***Rover Pipeline Project***

***Response to FERC  
Environmental Information Request  
Dated June 16, 2015***

***FERC Docket No. CP15-93-000***

**Figure 7-3. Typical Levels of Ground-Borne Vibration**

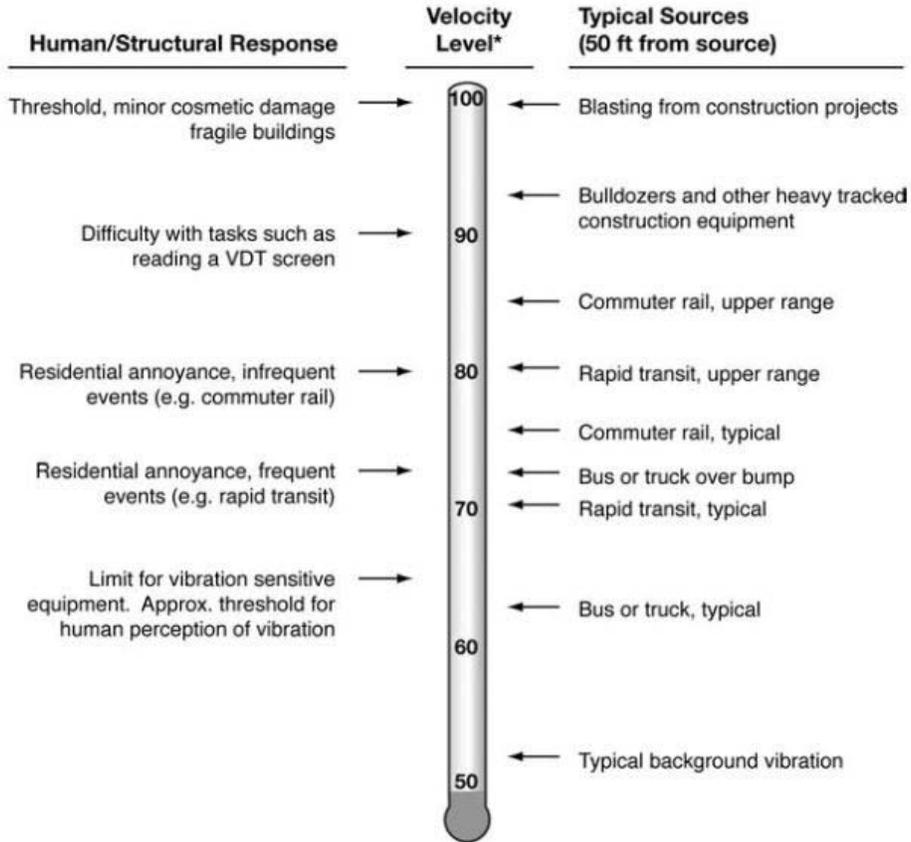
5. *Provide documentation, including estimates of existing vibration levels and potential vibration from construction and operation activities, to support Rover's statement that no "perceptible increase in ground-borne vibration" would be expected.*

In Figure 7-3 of the Handbook, included below, the FTA gives some typical ground vibration velocity levels for various vibration sources and locations, along with the human/structural response to those vibrations. As discussed in the Handbook, most residential areas will have minimal background vibration unless they are adjacent to railroads or traffic on rough roads. Based on our review of the aerial photography for the Project work areas, we would expect that existing ground vibration velocity levels would be in the 40 to 55 VdB range, with VdB denoting decibels referenced to  $10^{-6}$  inches per second.

The largest Project compressor station proposed is Mainline CS 1, with approximately 42,190 hp of compression. Using a  $10 \cdot \log(\text{horsepower ratio})$  adjustment for the measured ground vibration levels, a horsepower adjustment factor of  $10 \cdot \log(42,190 / 5,325)$ , or +9.0 dB, is calculated. With this adjustment, the anticipated ground vibration levels at 150 feet from the Mainline CS 1 compressor building would be at most  $48.5 + 9 = 57.5$  VdB. As shown in Figure 7-3 of the Handbook, 57.5 VdB is lower than the approximate threshold of human perception of vibration. This calculation is for 150 feet from the compressor building. The closest Project NSAs are more

than 700 feet away from the Project compressor buildings and should not experience perceptible ground-borne vibration during facility operation.
